MEMORANDUM

Date: January 6, 2016 Our File: 1010-20-13-005
To: Lower Caulfeild Advisory Committee
From: Lisa Berg, Senior Community Planner
Re: **Heritage Alteration Permit No. 13-005 for 4768 The Highway (second submission)**

TITLE:	CONTEXT PLAN	DATE: JAN 16/13	REV: 0
	4768 The Highway	13-005

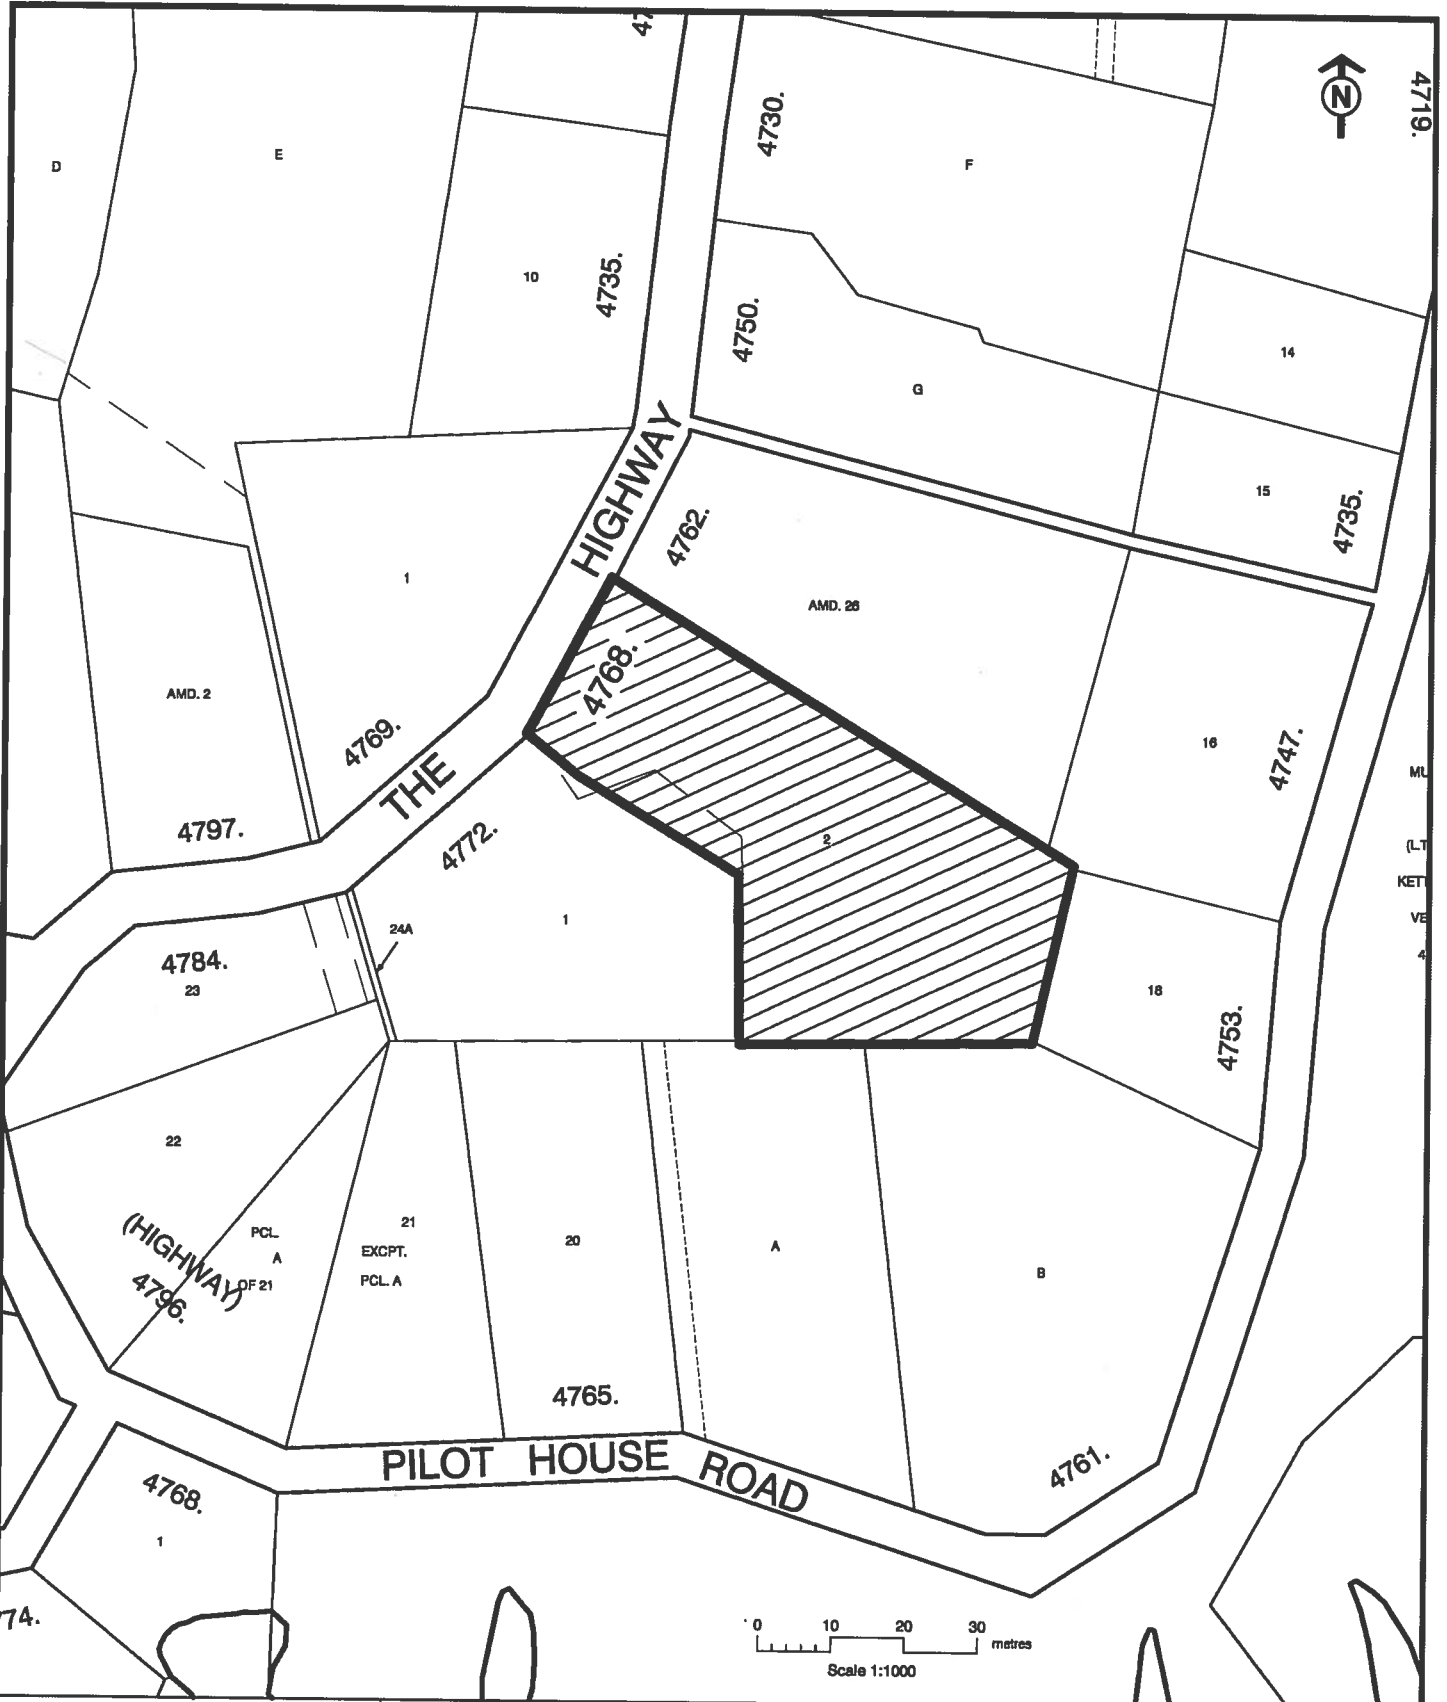
This memo deals with the application for a Heritage Alteration Permit at 4768 The Highway (**Appendix A**) that was previously considered by the LCAC.
